Project	IEEE 802.16 Broadband Wireless Access Working Group < http://ieee802.org/16 >
Title	Figure F7 Change and addition
Date Submitted	2007-01-16
Source(s)	Peretz Feder, Honghai Zhang – ALU [mailto: pfeder@alcatel-lucent.com , hozhang@alcatel-lucent.com] Philip Barber - Huawei pbarber@huawei.com
Re:	
Abstract	Changes to Figure F7
Purpose	Adoption
Notice	This document has been prepared to assist IEEE 802.16. It is offered as a basis for discussion and is not binding on the contributing individual(s) or organization(s). The material in this document is subject to change in form and content after further study. The contributor(s) reserve(s) the right to add, amend or withdraw material contained herein.
Release	The contributor grants a free, irrevocable license to the IEEE to incorporate material contained in this contribution, and any modifications thereof, in the creation of an IEEE Standards publication; to copyright in the IEEE's name any IEEE Standards publication even though it may include portions of this contribution; and at the IEEE's sole discretion to permit others to reproduce in whole or in part the resulting IEEE Standards publication. The contributor also acknowledges

Figure F7a – MS Initiated HO: End-to-End HO exchange between MS, Serving BS and Target BS

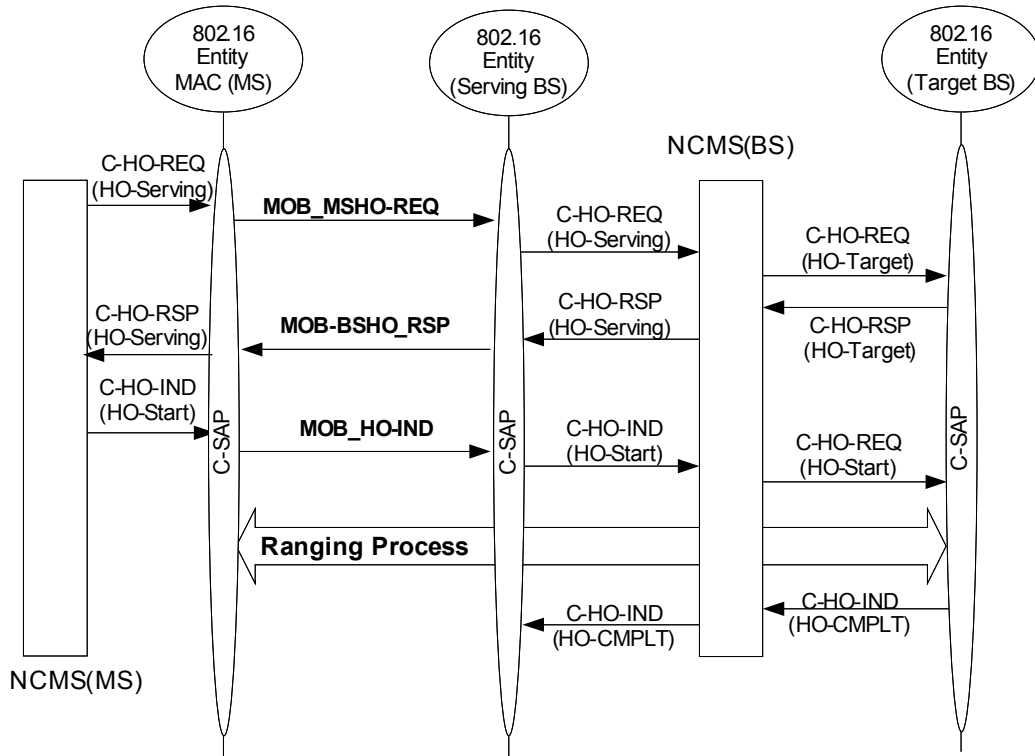
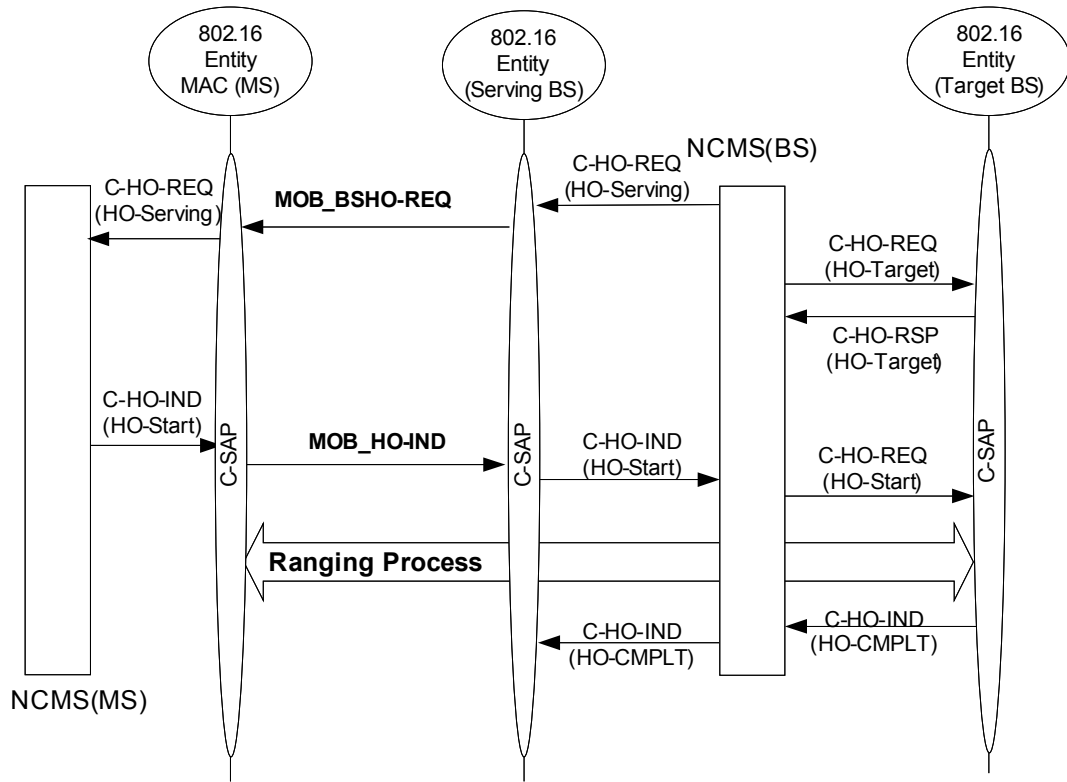
5 Update Figure F7 indicating BS and MN initiated handover using C-HO-
6 REQ/RSP (HO-Serving) primitives
